FXi 60/250 Exciter L1 Field Retrofit Application Guide

597-0541-L1 Revision B January 24, 2012

Figure 3 – Remove old style L1.

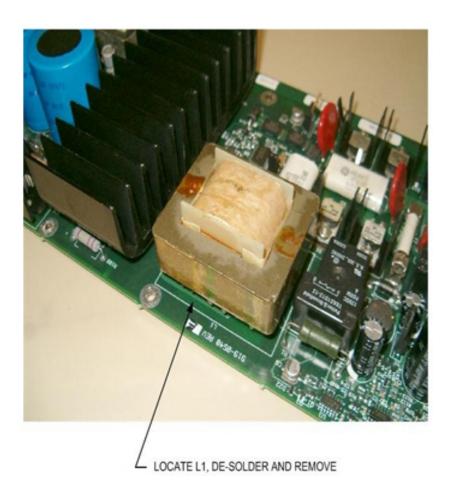
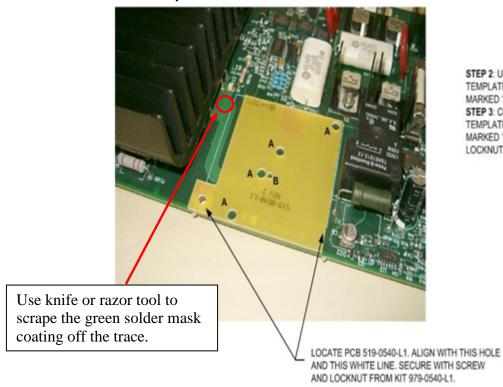
Problem: To improve the reliability of the main FXi 60/250 exciter power supply, it is recommended that L1 be replaced with an enhanced torroid coil. L1 on the power supply can overheat and cause a power failure, damaging the power supply board.

Locate L1 and de-solder from board.

Fix: The upgrade consists of removal of the existing L1, and installing a torroid L1 with a spacer underneath.

Figure 5 -Installing new L1ed

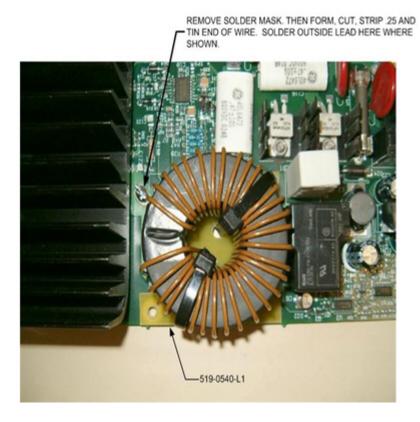
Leaving the template on the Power Supply board; insert the inside lead from the inductor provided in the kit (360-5812) through the small hole. Bend, form and cut the outside lead to fit onto the surface of the Power Supply board to the area scraped previously, Shown below.

Secure the inductor using two tie wraps 402-0015 from kit. Solder lead to trace on Power supply board.

Figure 7 – Install long screw.

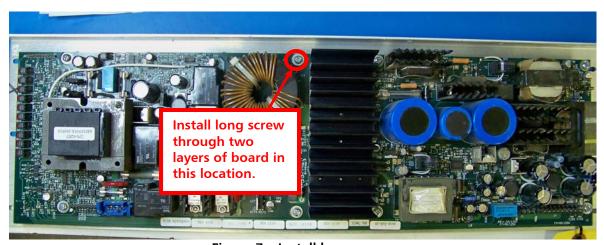
Install the Power Supply board back onto the panel using the existing hardware and one long screw and internal lock washer provided in kit in the hole that is now through the template and the power supply board.
